PROPOSED AMENDMENTS TO THE 2021 INTERNATIONAL CODES

**FOR REVIEW BY:
MURPHY BUILDING &
FIRE CODE APPEALS BOARD**

Project: Proposed Amendments to the 2021 IRC, IEBC, IECC, IMC, IFGC, IPC, IPMC, ISPSC, IBC, and 2020 NEC.

ADD: Figure: 25 TAC §265.186 (e) (6)

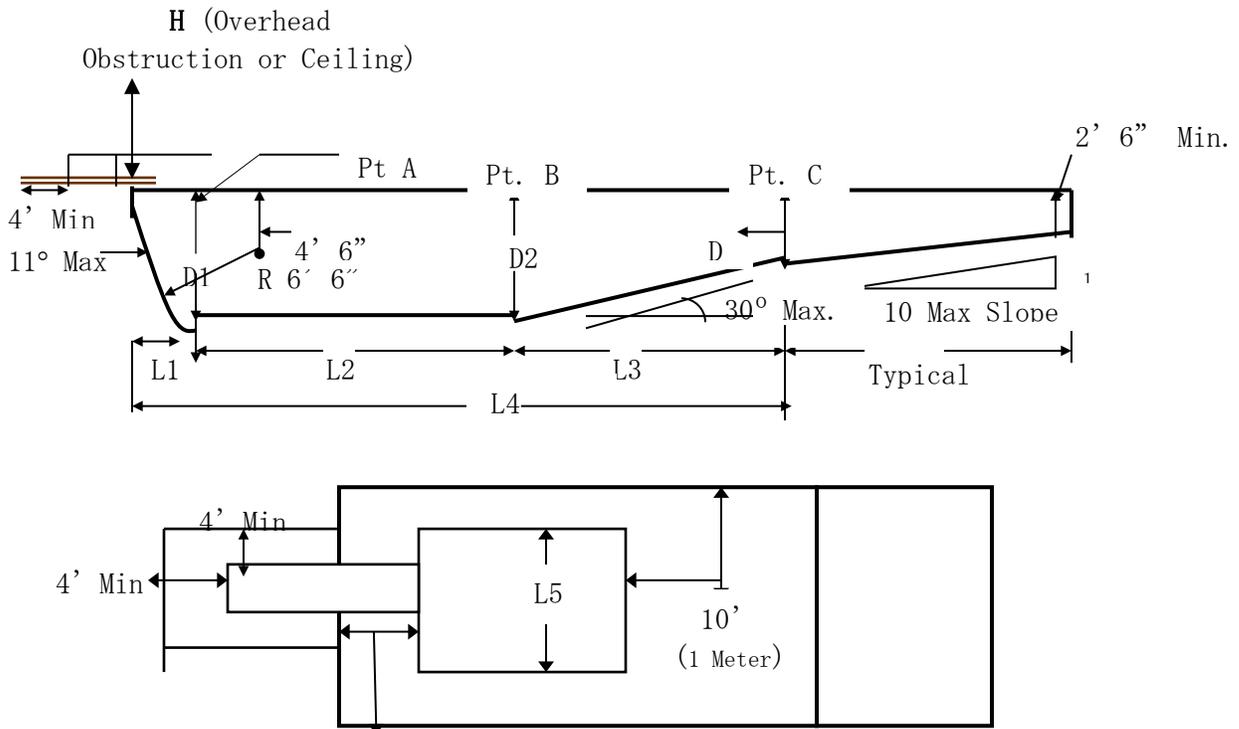
****Section 402.12; Change to read as follows:**

402.12 Water envelopes. The minimum diving water envelopes shall be in accordance with the -Texas department of State Health services, Administrative Code Title 25, Chapter 265, Section 186 (e) and Figure: 25 TAC 256.186 (e) (6). (Delete Table 402.12 and Figure 402.12)
